CITY OF HOBART

CITY INFRASTRUCTURE COMMITTEE MEETING (OPEN PORTION OF THE MEETING)

WEDNESDAY 25 MAY 2016

- 2. CONSIDERATION OF SUPPLEMENTARY ITEMS TO THE AGENDA**
- 3. INDICATIONS OF PECUNIARY AND CONFLICTS OF INTEREST**
- 4. TRANSFER OF AGENDA ITEMS**
- 5. GIBLIN STREET TRAFFIC ISLAND - OUTCOME OF ROAD - SAFETY AUDIT – FILE REF: R0521**

Figure 4 Driveway to 98 Giblin Street

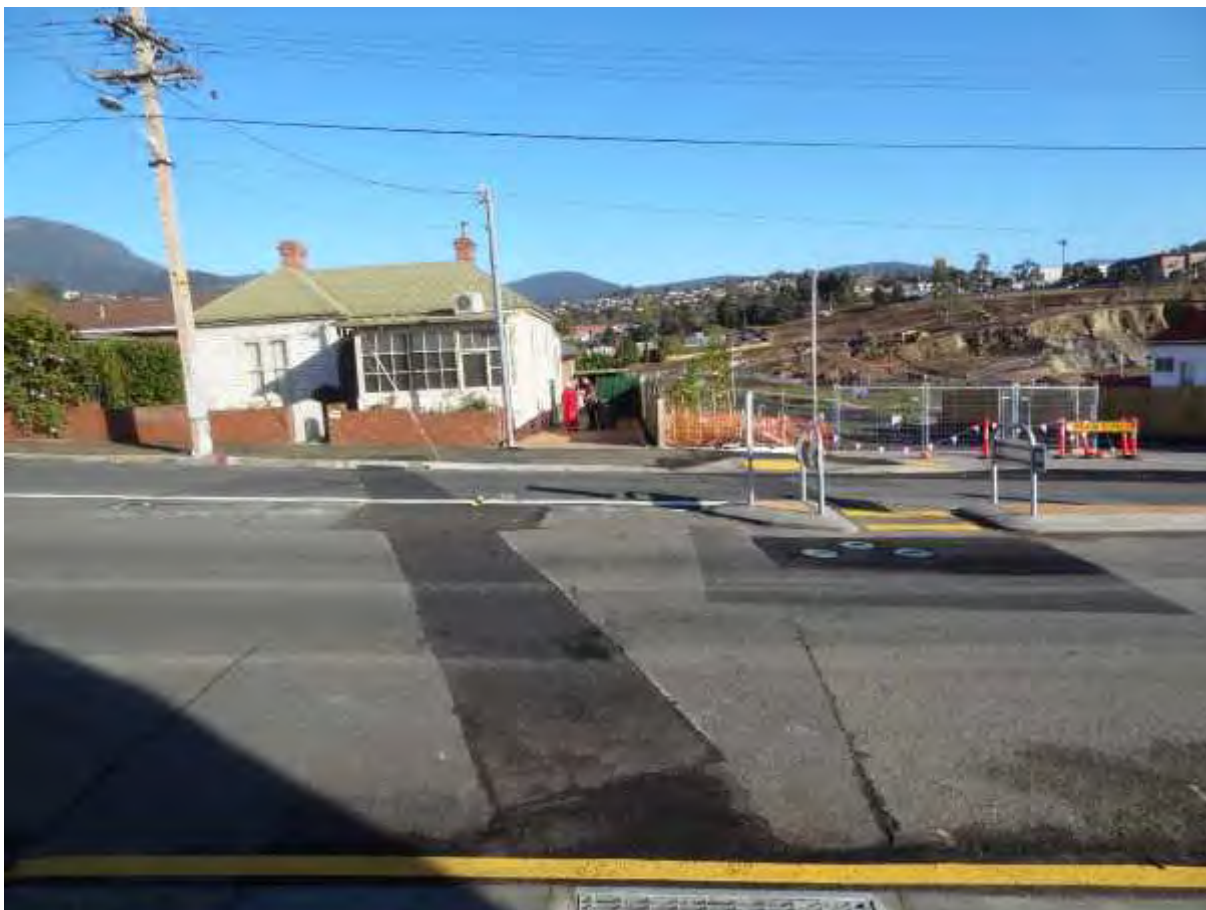
| Comment | Direction | Frequency / Severity | Risk | Photo Reference | Potential Remedial Actions | Residual Frequency / Severity | Residual Risk | Road Authority Response |
|--|-----------|----------------------|------|-----------------|--|-------------------------------|---------------|-------------------------|
| Vehicles turning right into No. 98 driveway must turn more than 90 degrees to avoid impact with the refuge island. | SB | Occasional / Limited | Low | Figure 4 | Remove or relocate refuge island | Improbable / Limited | Low | |

| Comment | Direction | Frequency / Severity | Risk | Photo Reference | Potential Remedial Actions | Residual Frequency / Severity | Residual Risk | Road Authority Response |
|---|-----------|----------------------|--------|-----------------|--|-------------------------------|---------------|--|
| Vehicles turning right into No. 98 driveway must turn more than 90 degrees to avoid impact with the refuge island. | SB | Occasional / Limited | Low | Figure 4 | Remove or relocate refuge island | Improbable / Limited | Low | No action deemed necessary as changing or removing the island does not reduce the risk. |

Figure 6 – Right side of Macquarie Street (upstream from Murray Street)

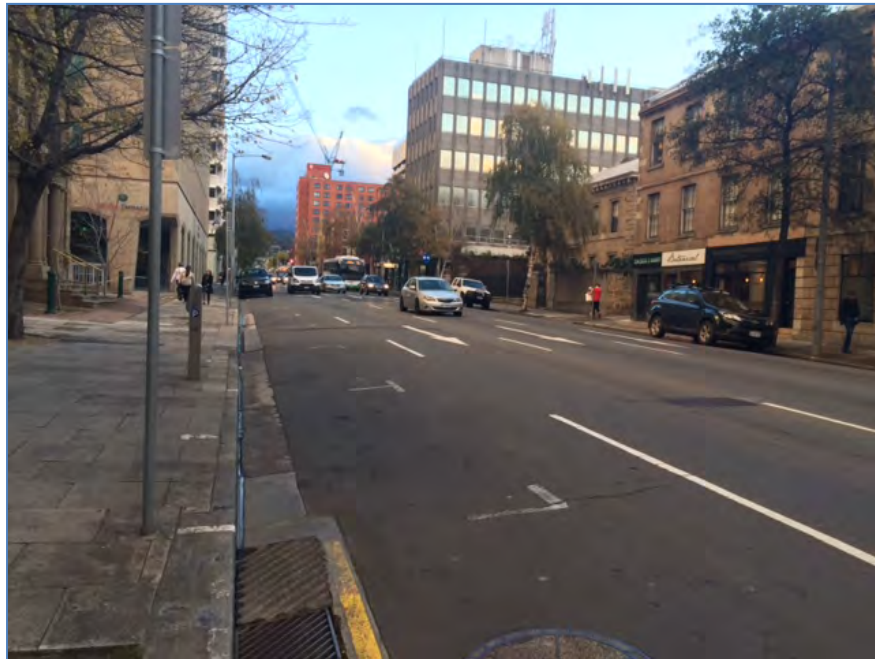
3.8.1. Macquarie Street between Harrington Street and Murray Street – the existing clearway (operating between 7.30-9am and 4-6pm, Monday to Friday) is currently provided for a distance of 55 m back from the Murray Street intersection (see Figure 6). It is proposed to extend this clearway further towards Harrington Street.

It should be noted that the combined width of the through lane and parking lane may not be sufficiently wide to safely provide for two traffic lanes during peak periods beyond the existing clearway length.

Observations are that this suggested clearway extension is not necessary at this time as during normal operating conditions the queues rarely extend beyond the existing clearway length.

Figure 8 – Murray Street at Collins Street

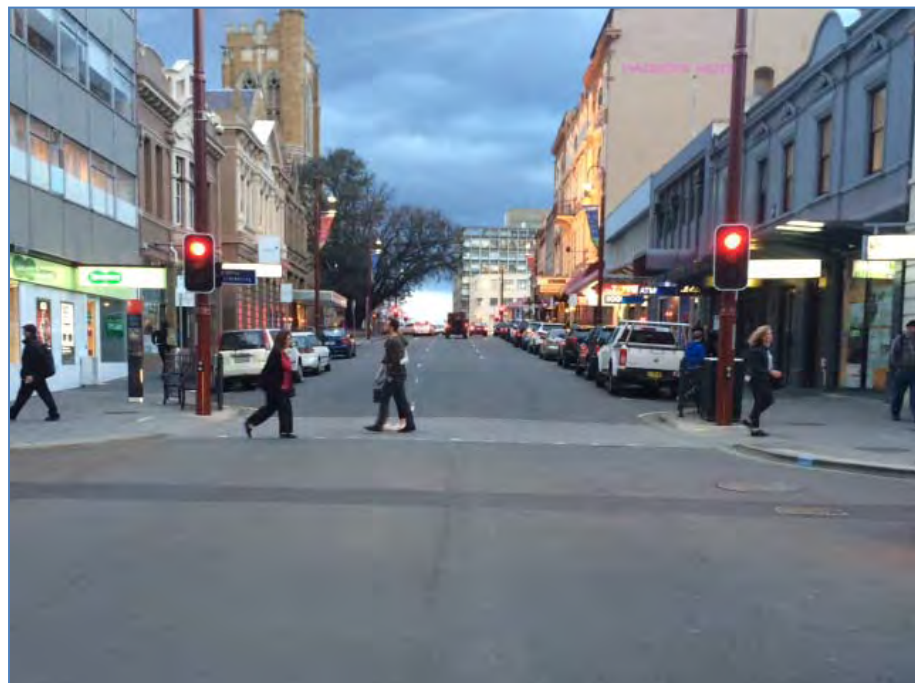
3.9.1. Murray Street at Collins Street and Macquarie Street (see Figure 8).

The proposal is to allow for three traffic lanes to continue along Murray Street across Collins Street. However, the current kerb bulbing restricts the available width at this location. To provide for these changes would require alteration to the kerb bulbing on the southern side of the intersection, relocation of traffic signal lanterns and the possible loss of some on-street parking.

This in turn would have a slightly detrimental impact on pedestrian amenity at this busy intersection due to the reduced waiting space and longer crossing distance.

However, further investigation could be undertaken to determine the extent of the alterations required and the likely cost of works.
